**US OIL RECOVERY SUPERFUND SITE  
WORK PLAN REFINEMENT/MODIFICATION NOTICE**

**WORK PLAN REFINEMENT/MODIFICATION NOTICE NO.:** WRN AO1-1-8

**DATE:** December 10, 2018

This Work Plan Refinement/Modification Notice (WRN) describes the details for the work proposed for additional activities associated with Iteration 2 of the RI/FS. This WRN describes a sediment reconnaissance study of Vince Bayou, describes how additional delineation sample locations will be selected, and provides a proposed analyte list for the additional delineation samples.

Figure 1

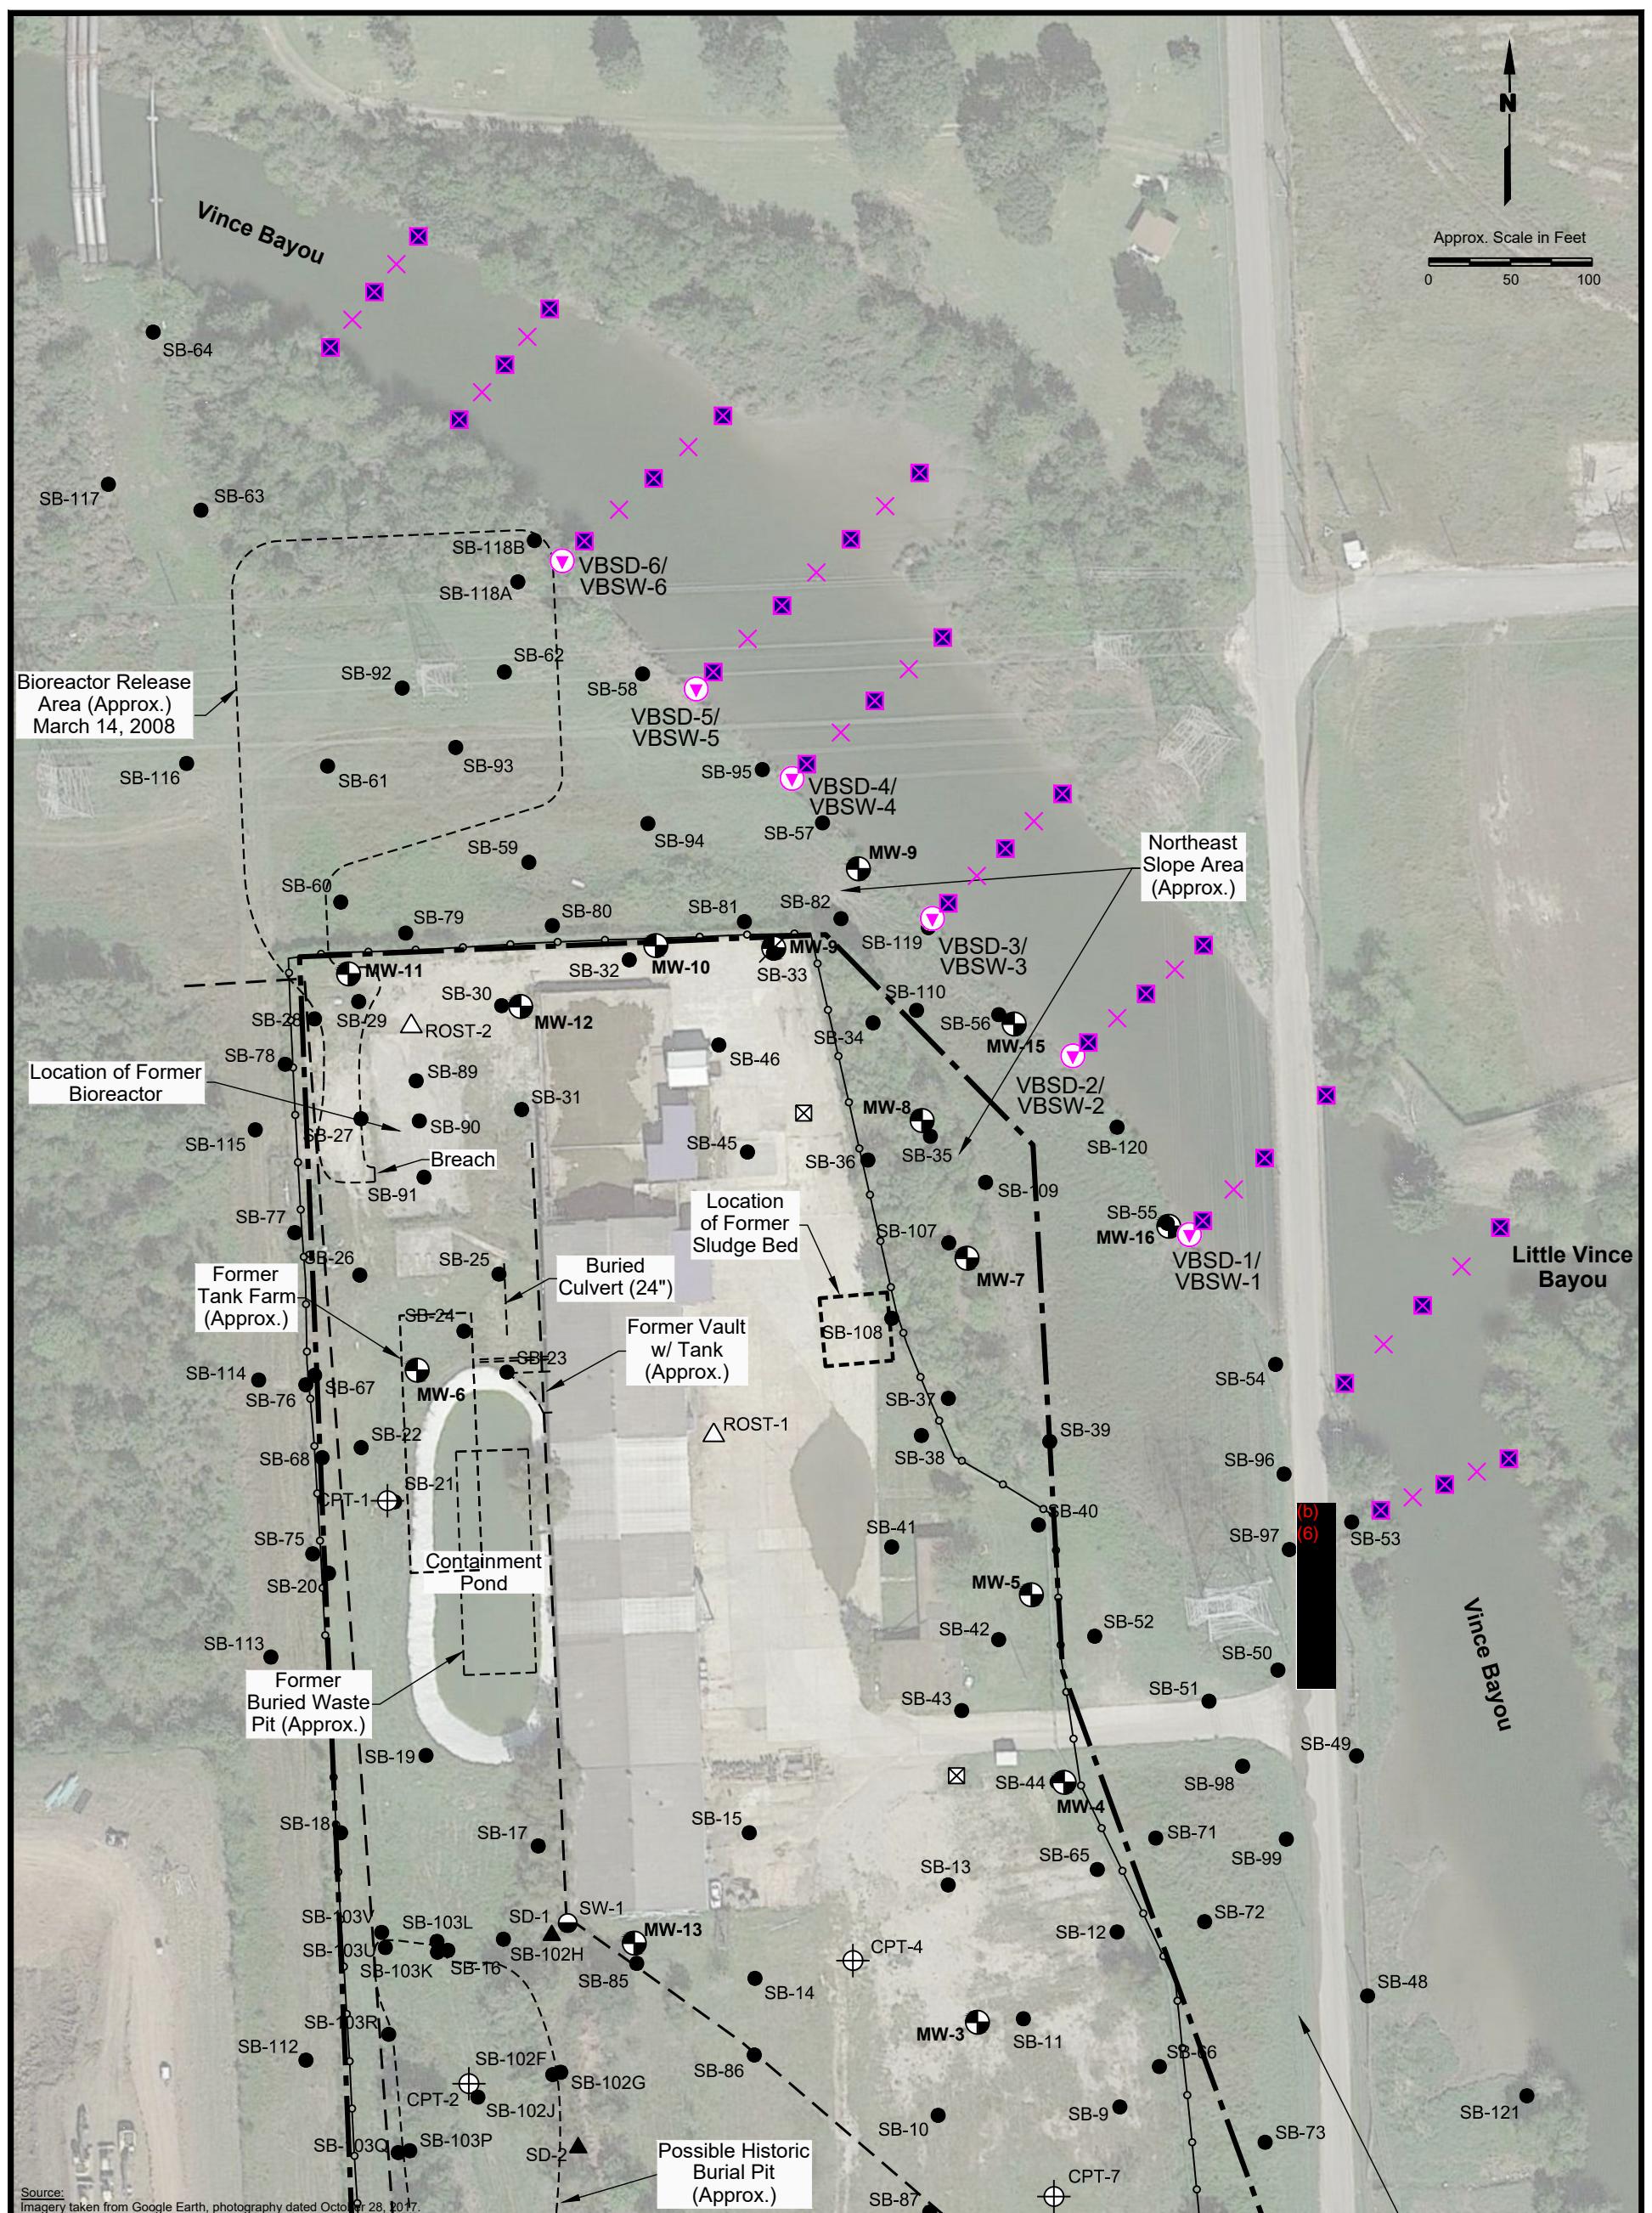
The sediment reconnaissance study will be performed within the general area proposed for additional COPC delineation sampling, which includes 10 shoreline-to-shoreline transects that are upstream, downstream and across the bayou from the original sampling locations from WRN-7 (see attached map, Figure 1). Each transect will consist of five sample locations across the bayou (except at VBSD-5 where it will be extended into a low energy feature across the bayou). The sampling procedures for the reconnaissance study are as follows:

- 4) Three of the five sediment samples along each transect (near-shore, mid-channel, far-shore) will be analyzed for grain size and total organic carbon (TOC) (see Figure 1). As noted in the above discussion, two additional sediment samples will be collected along the transect near VBSD-5 with one being analyzed for grain size and TOC. Fraction organic carbon (FOC) will be calculated by the lab for each sample that is analyzed for grain size and TOC.

FIGURE  
2

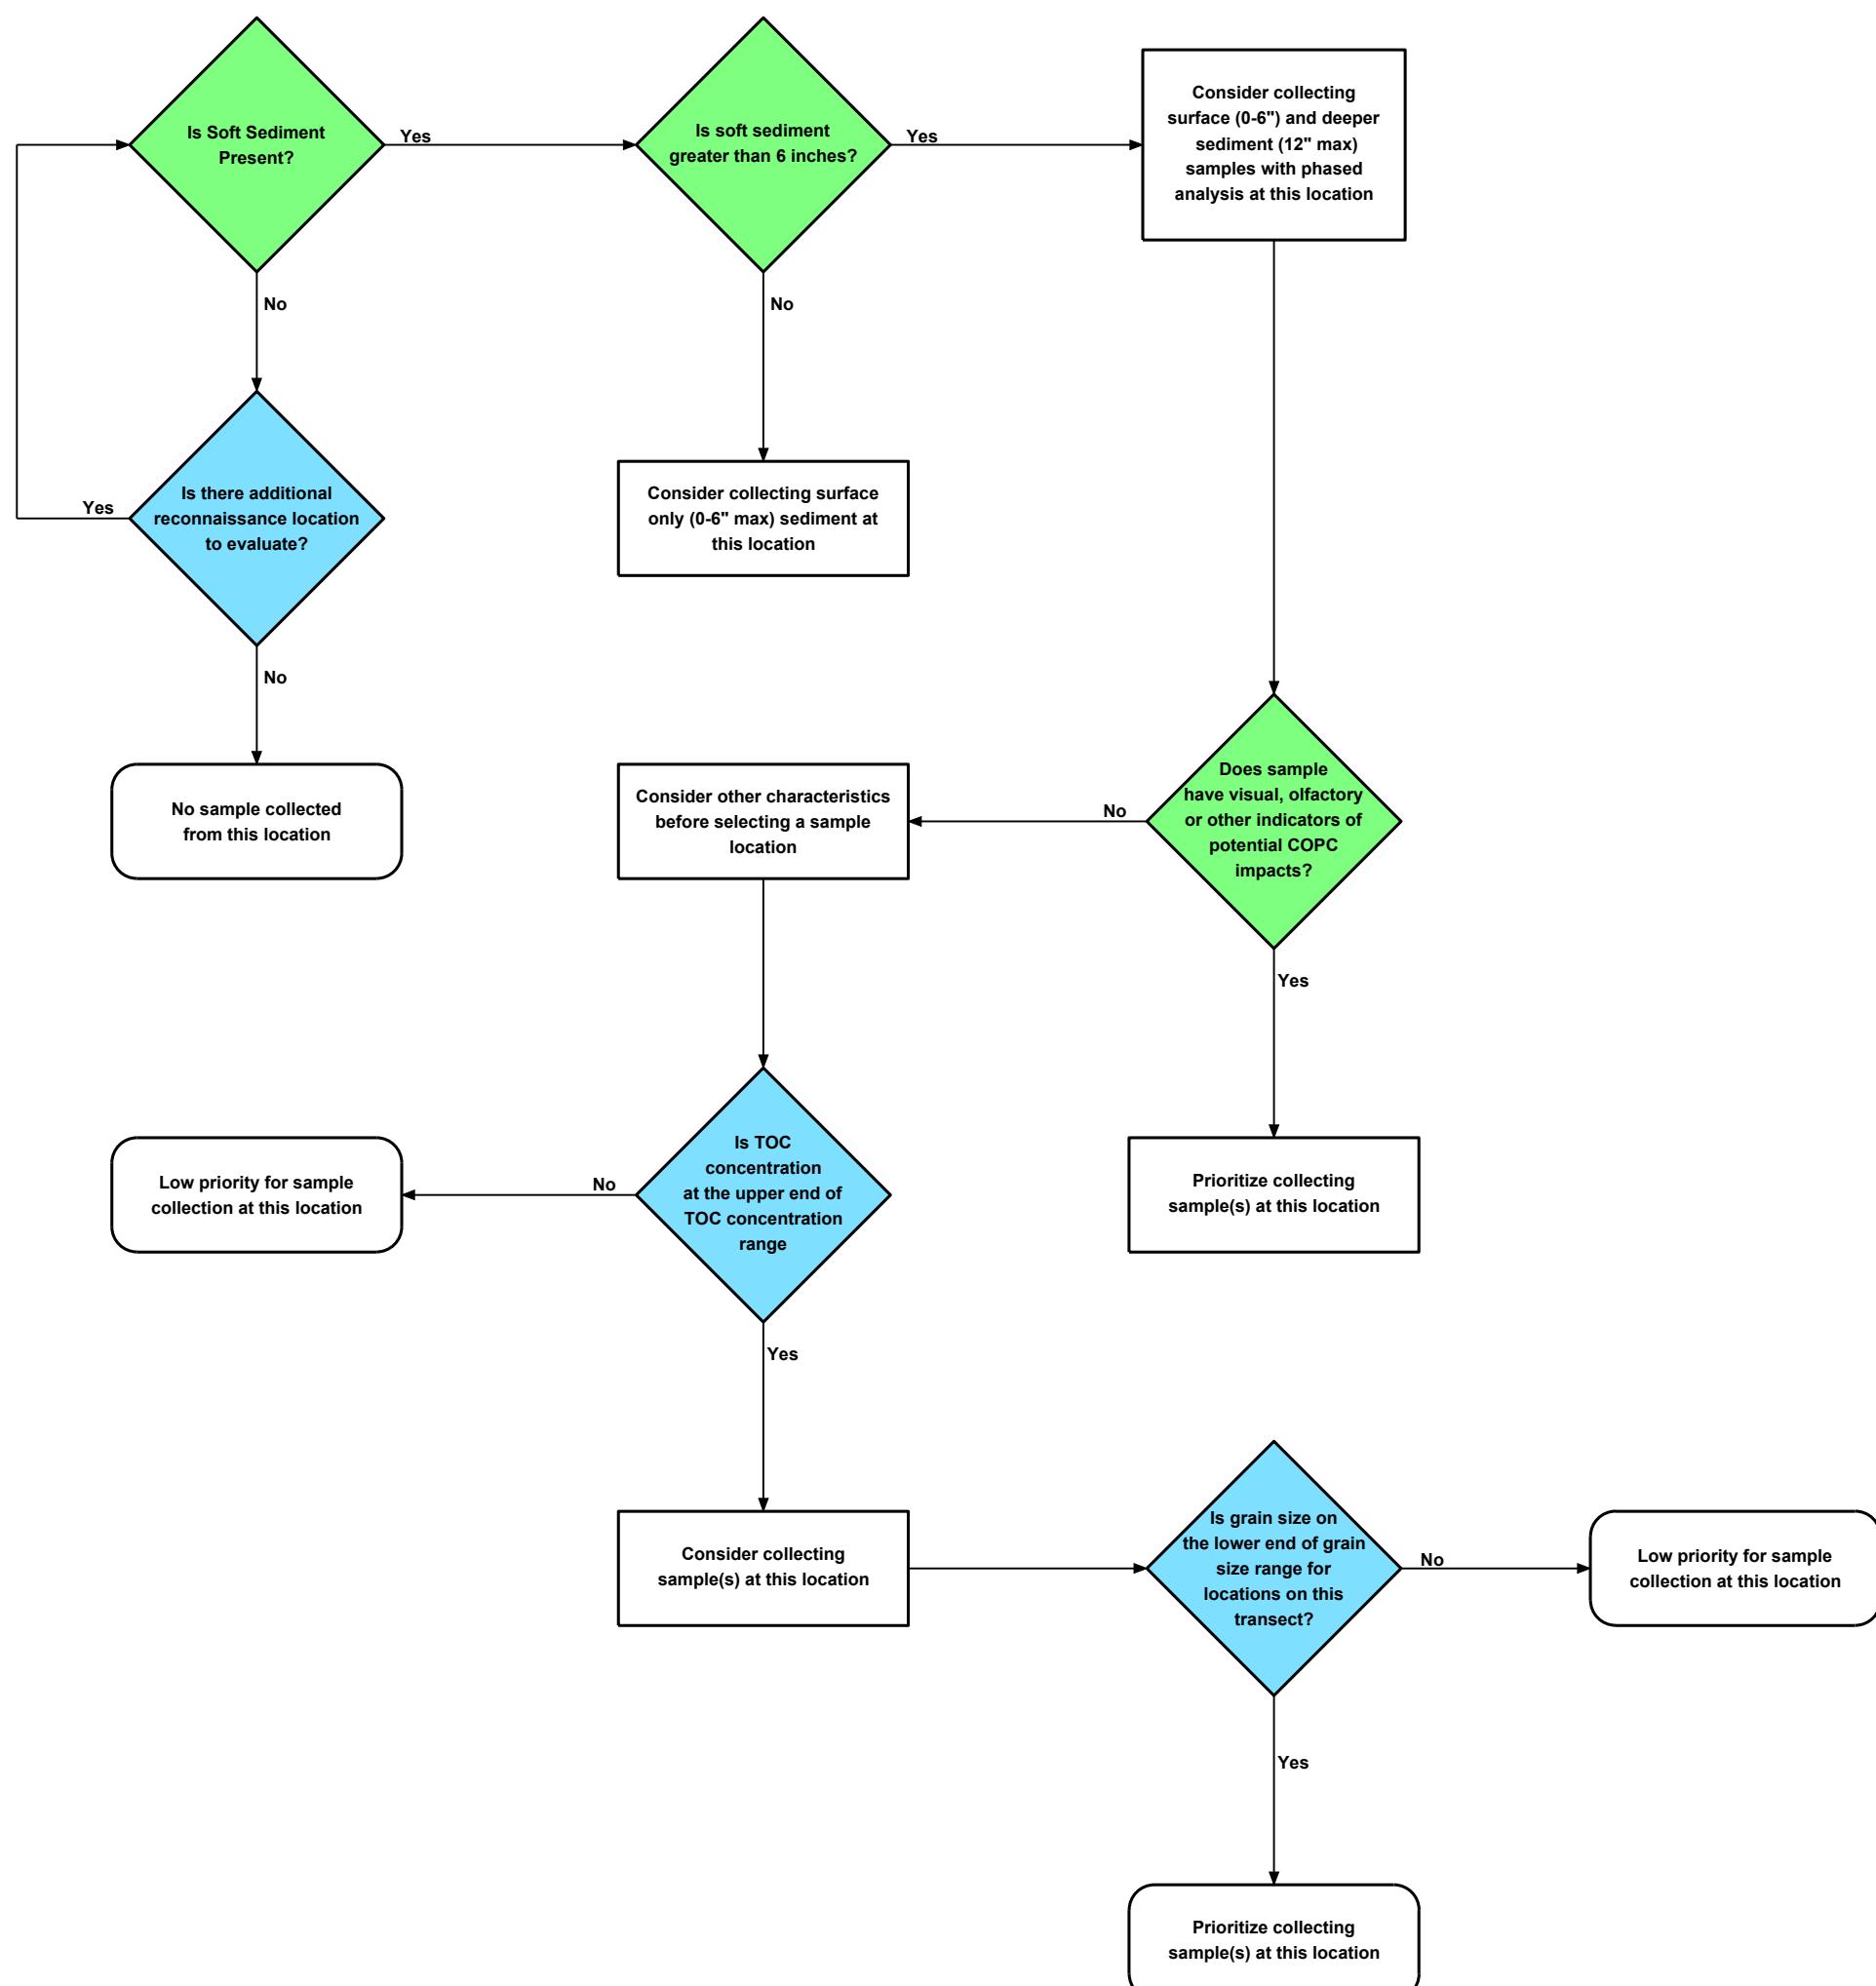
- 1) Generally, six step-out locations (final locations selected using the process defined on Figure 2) to laterally delineate sediment preliminary screening values (PSVs) exceedances measured in samples collected from VBSD-1 through VBSD-6 will be sampled. It is envisioned that these six step-out samples will be collected further into the bayou away from the shoreline locations VBSD-1 through VBSD-6.

- 2) In addition, two upstream delineation samples (final locations selected using the process defined on Figure 2) will be collected south of VBSD-1 and two downstream delineation samples will be collected north of VBSD-6.
